ATA6663/64 Errata and Data Sheet Clarifications

The functionality of the automotive qualified ATA6663/64 devices you have received is described in the Device Data Sheet 9146I-AUTO-10/14 except for the anomalies described in this document.

In the device data sheet 9146I-AUTO-10/14, the following clarifications and supplements should be noted:

8-Lead Plastic Small Outline (SN) - Narrow, 3.90 mm (.150 In.) Body [SOIC]

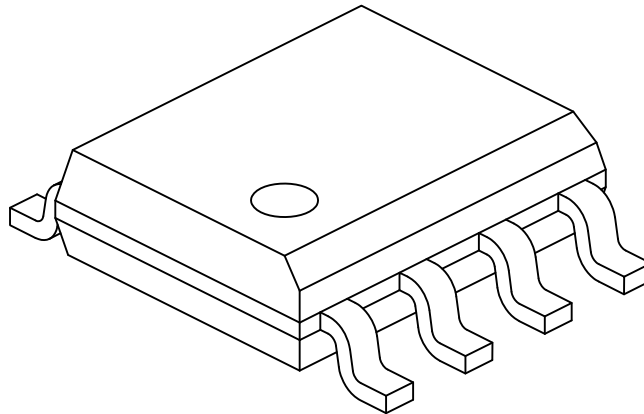
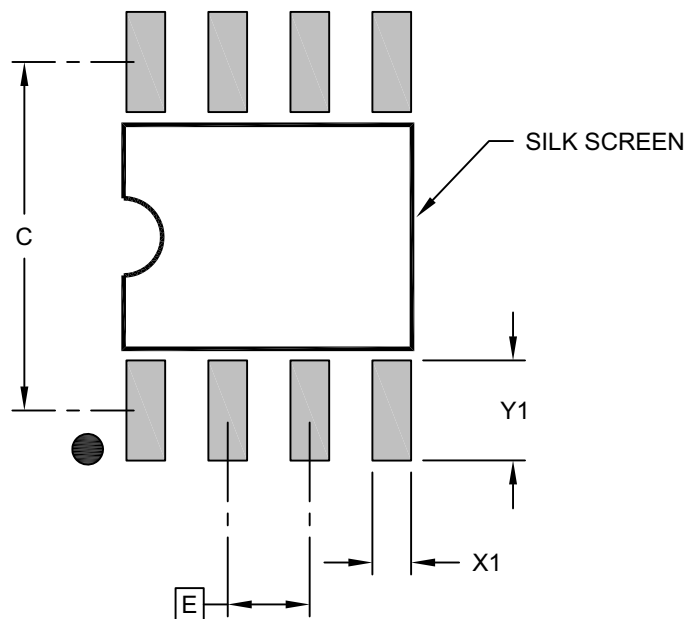
The package drawings have been updated. They have been converted from the former Atmel style to the Microchip Format.

For the 8-lead SOIC package, the dimensions are identical, there are no changes in any dimensions.

8-Lead Very Thin Plastic Dual Flat, No Lead Package (Q8B) - 3x3 mm Body [VDFN] With 2.40x1.60 mm Exposed Pad and Stepped Wettable Flanks; Atmel Legacy YCL

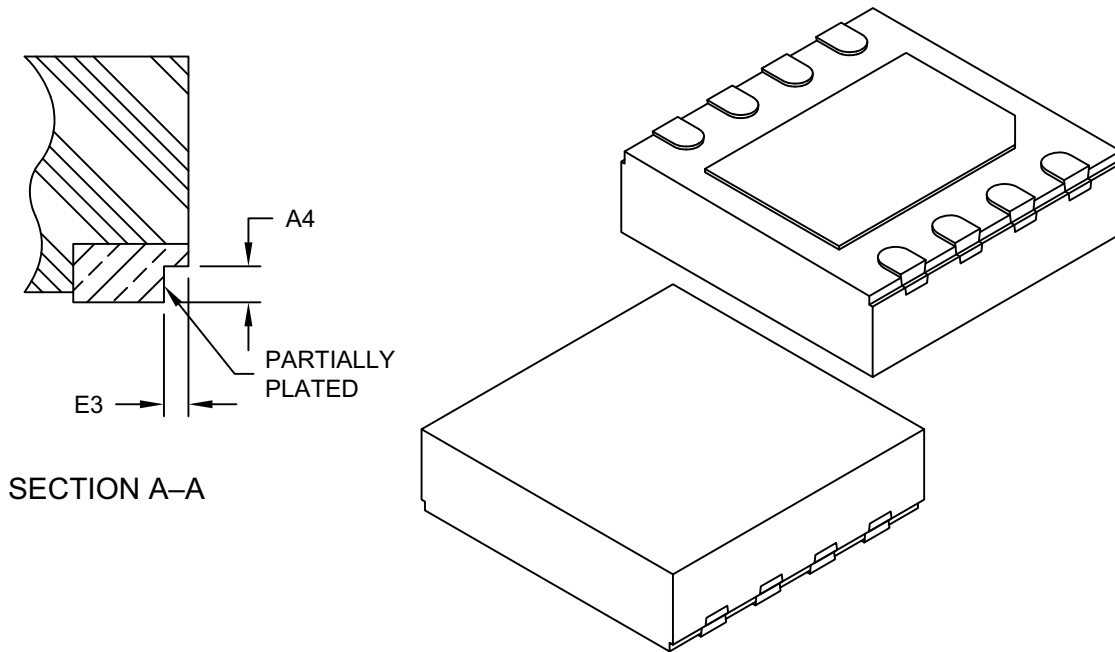
For the ATA6663 in the 8-lead VDFN package, the only dimensions which are different are listed in the following table:

OLD			NEW			
Dimension	Symbol	Min.	Nom.	Max.	Min.	Nom.	Max.	Units
Overall Height	A	0.80	0.85	0.90	0.80	0.90	1.00	mm
Wettable Flank Step Length	D3	—	—	0.040	—	—	0.085	mm
Wettable Flank Step Heights	A4	0.10	—	0.15	0.10	—	0.19	mm
